# UNITED STATES PATENT AND TRADEMARK OFFICE

10/662,751

James D. Goss

<b>Office Action Summary</b>	<b>Application No.</b> 10/662,751	<b>Applicant(s)</b> GOSS ET AL.	
	<b>Examiner</b> JUSTIN KRAUSE	<b>Art Unit</b> 3682

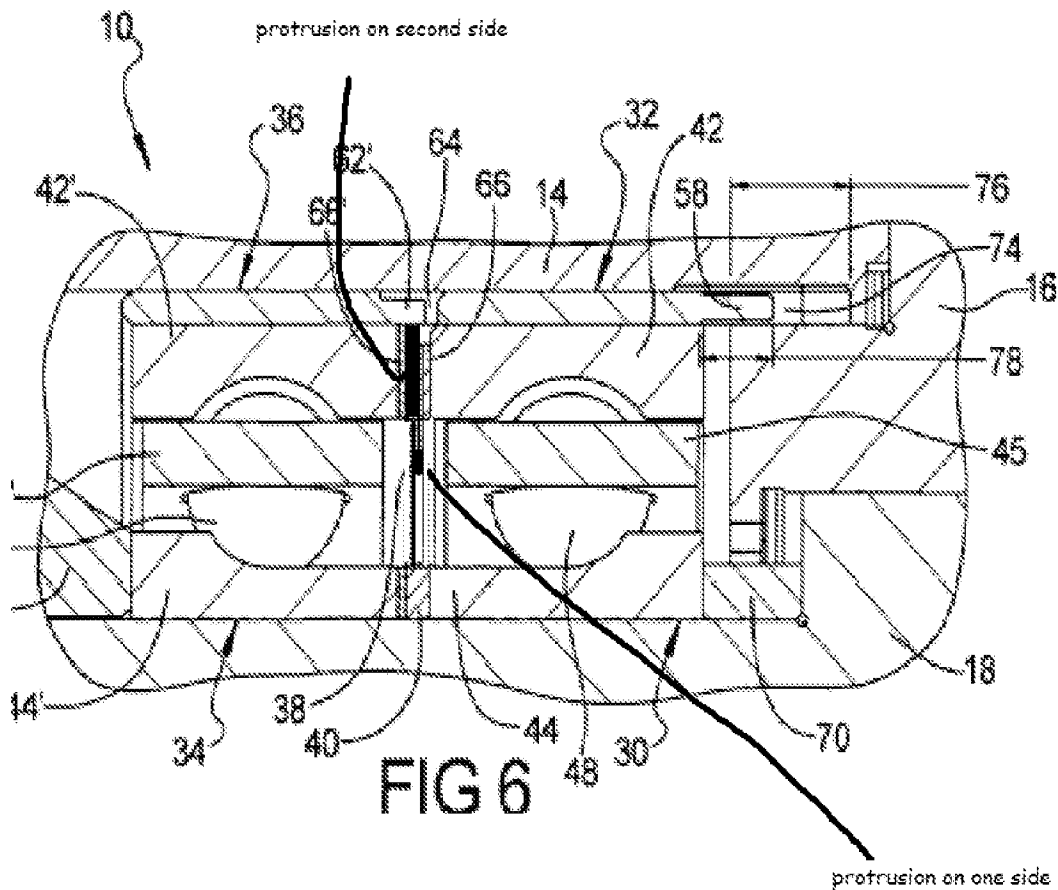
Upon further review of figure 6, the examiner believes to have located the protrusion of opposite sides of the spring.

The spring, in the examiner's view, is illustrated above in black. If this is the case, then the original drawing should be filed, with proper cross hatching. Amended figure 6 as filed July 9, 2008 will not be entered as it deviates significantly from what was originally illustrated. Figure 2 filed on November 27, 2007 should also be filed in response to this Office Action. No other drawings filed November 27, 2007 will be entered.

Corrected drawing sheets in compliance with 37 CFR 1.121(d) are required in reply to the Office action to avoid abandonment of the application. Any amended replacement drawing sheet should include all of the figures appearing on the immediate prior version of the sheet, even if only one figure is being amended. The figure or figure number of an amended drawing should not be labeled as "amended." If a drawing figure is to be canceled, the appropriate figure must be removed from the replacement sheet, and where necessary, the remaining figures must be renumbered and appropriate changes made to the brief description of the several views of the drawings for consistency. Additional replacement sheets may be necessary to show the renumbering of the remaining figures. Each drawing sheet submitted after the filing date of an application must be labeled in the top margin as either "Replacement Sheet" or "New Sheet" pursuant to 37 CFR 1.121(d). If the changes are not accepted by the examiner, the applicant will be notified and informed of any required corrective action in the next Office action. The objection to the drawings will not be held in abeyance.
